Subject: **FCC Class II Permission Change Request for FCC ID: UCZ-AY41TR-Z** Dear Sir/Madam,

This is to request a Class II Permission Change Request for FCC ID: UCZ-AY41TR-Z, originally granted on 2020/07/09.

1.updated main chip's Manufacturer

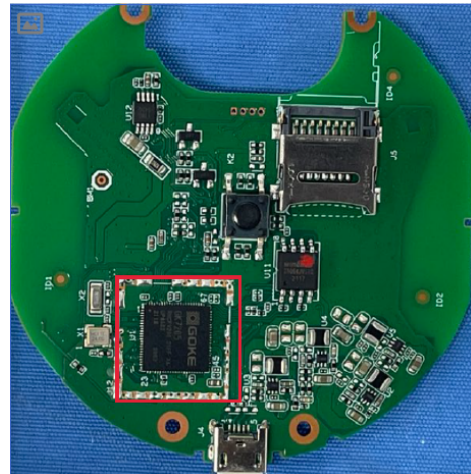
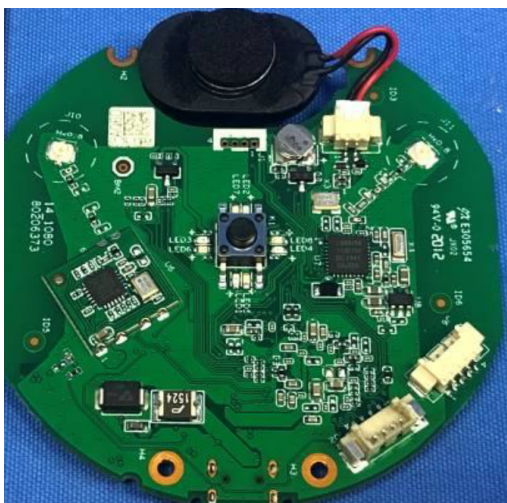
Before:

Now:

2.add a magnetic bead  
Before:

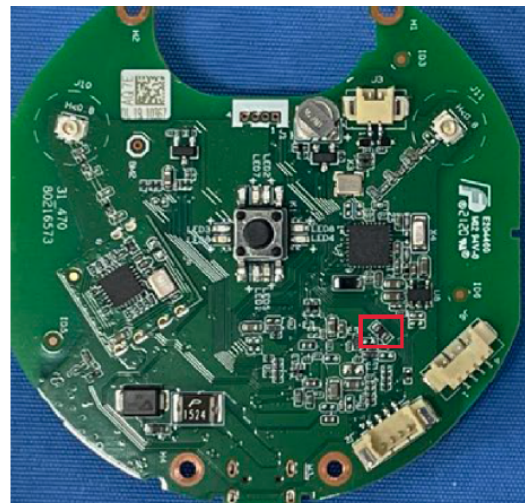
Now:
